TECH BULLETIN 135

Product changes to crankcase and bearing covers for all 25 and 28 Frame plunger and piston pumps

New Crankcase Style

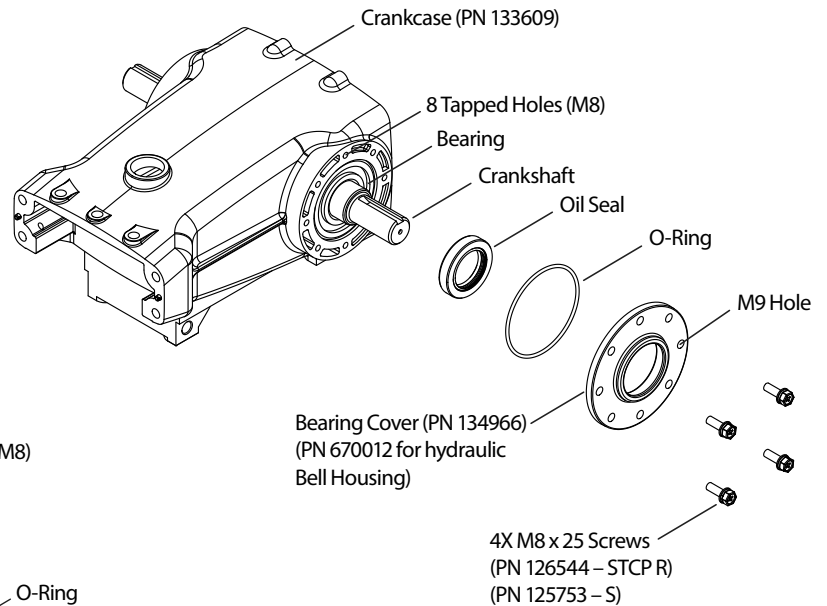
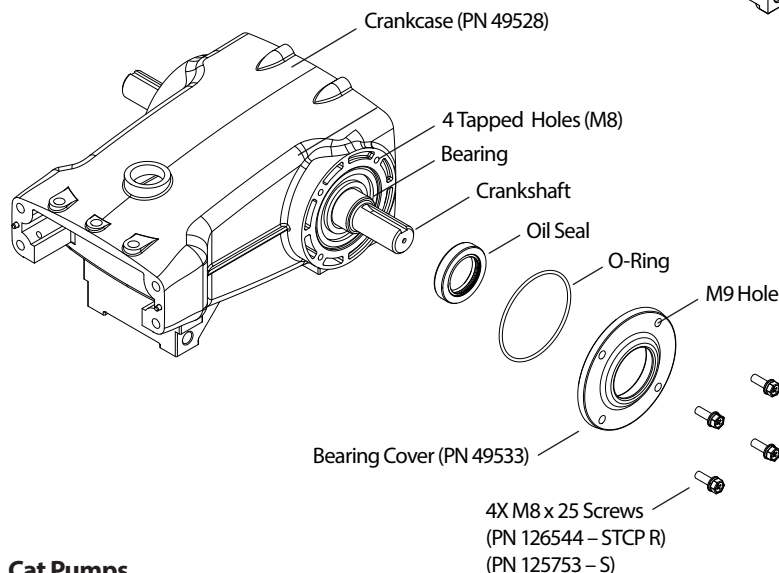
Changes have been made to the crankcase and mounting hardware to better support the weight of direct-drive hydraulic bell housings. This affects all 25 and 28 frame plunger pumps with date codes/serial numbers after July 2020.

- Crankcase bell housing mounting bolt holes number increased from four (4) to eight (8) to better distribute weight of hydraulic motor on crankcase.
- Bell housing mounting bolt quantity changed from four (4) M8 to eight (8) M8 bolts.

- Crankcase has eight (8) tapped holes on each side for hydraulic bell house mounting.
- Bearing cover has eight (8) through holes, but only supplied with four (4) M8 bolts.
- No change to the shaft protector.
